Technical Advisory Bulletin (TAB)

Bulletin #: TBBEE1618A

Product: BERNINA E16

Subject: 34801 Control Board Failures

Pic. 1: Original PCBA

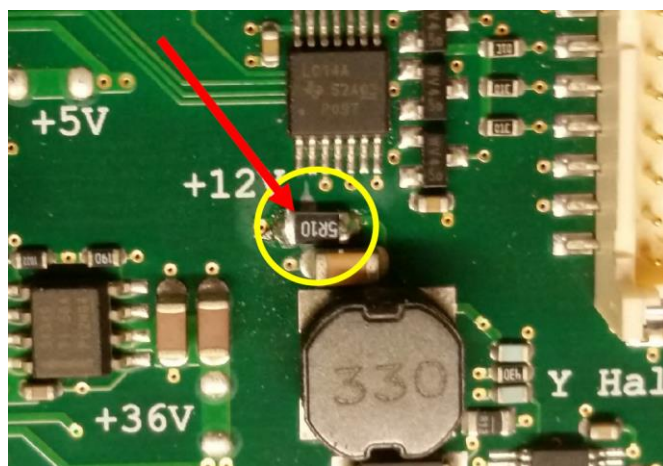
For existing Control Boards on new BERNINA E16 machines, as well as refurbished Control Boards, a 5 Ohm resistor has been added to lower inrush currents, see example in pictures 1 and 2 below.

Pic. 5: Original Driver Chip on the left and re-soldered new driver chip on the right

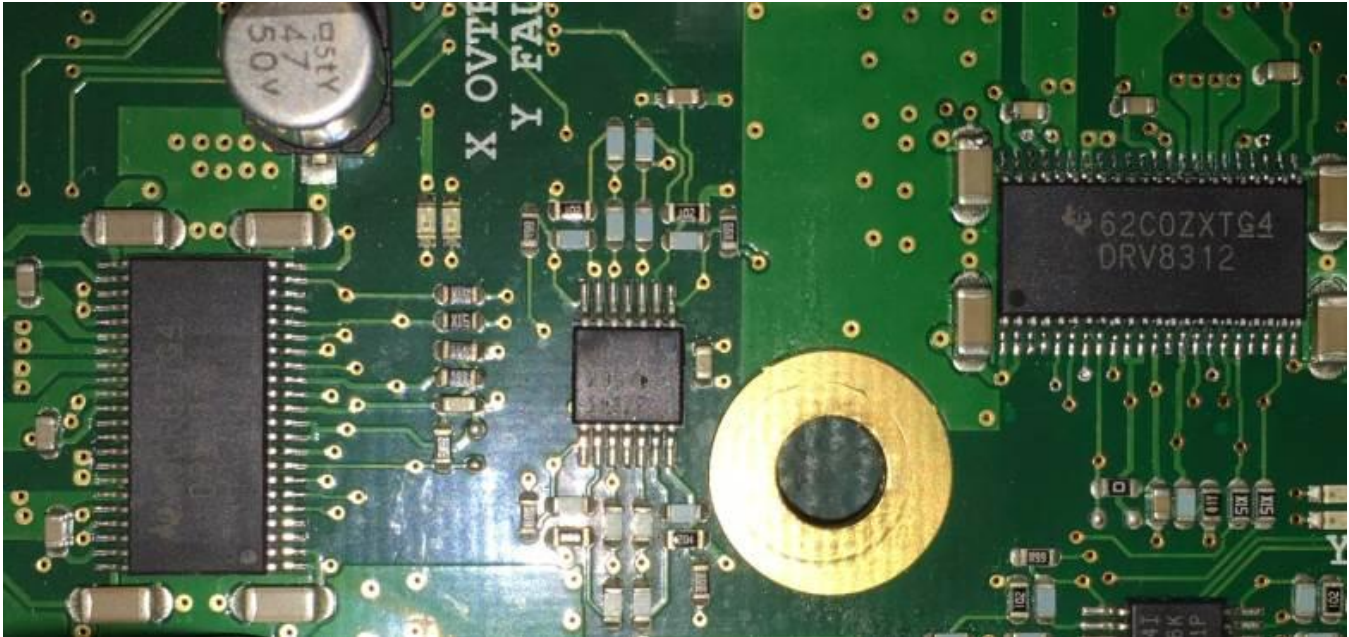
Unfortunately we have seen some of the reworked boards fail with the same symptoms. It is believed that the reason for these repeated failures is the fact that the driver chip had been somewhat compromised prior to the resistor rework being applied to boards that had already been run in machines.

For this reason Bernina started to replace the y-motor driver chip, in addition to adding the resistor, on all refurbished boards, starting on November 8, 2017. These boards are also marked with a red dot but can be distinguished by the somewhat irregular solder distribution around the y-motor chip pins, see picture below. Due to the quality of the rework, and therefore the fact that it is hard to tell whether the motor driver chip had been replaced, in case one of these second wave reworked boards fails in the field, the board in question needs to be sent back to Bernina for final determination/analysis.
